**CALIFORNIA REGIONAL WATER QUALITY CONTROL BOARD - SAN DIEGO REGION
WATERSHED PROTECTION PROGRAM**

FACILITY INSPECTION REPORT

FACILITY: Torrey Hills Unit 19 **INSPECTION DATE/TIME:** 09/20/2013; 1000

Figure 12. Sediment discharge outside site boundary

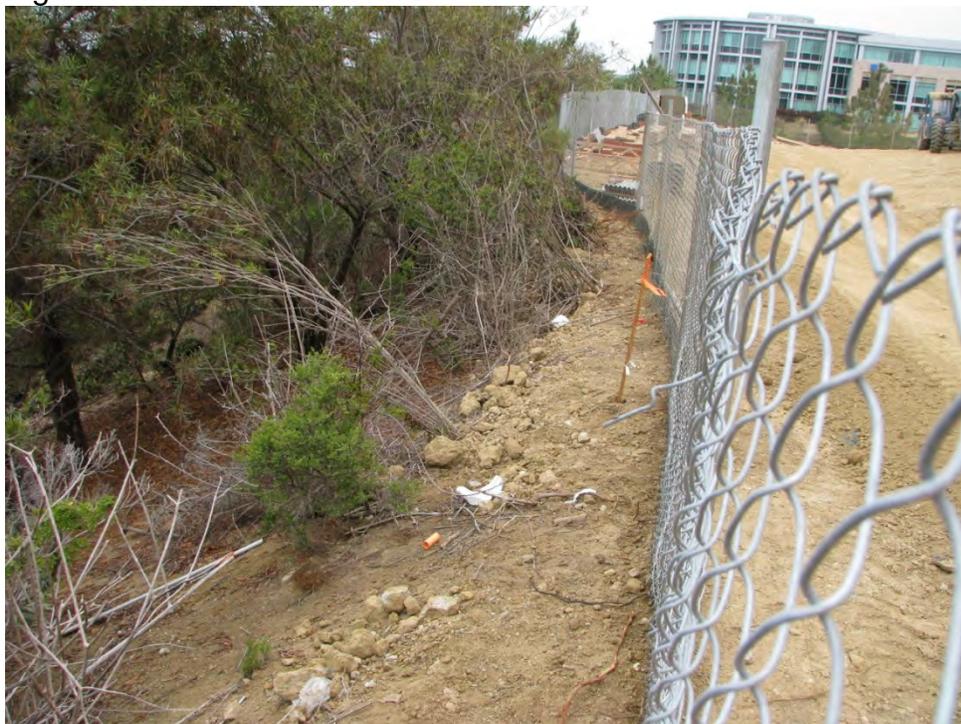
5. The site generally slopes towards the westerly direction. The perimeter controls along the west side were inadequate for containing the sediment within the construction site (Figures 10-12). There was evidence of a sediment discharge from the site and onto the adjacent downstream property (Figure 12).

3. The west side perimeter lacks adequate sediment controls to prevent sediment from leaving the site.
4. Sediment stockpiles should not be located near the edge of a steep slope.
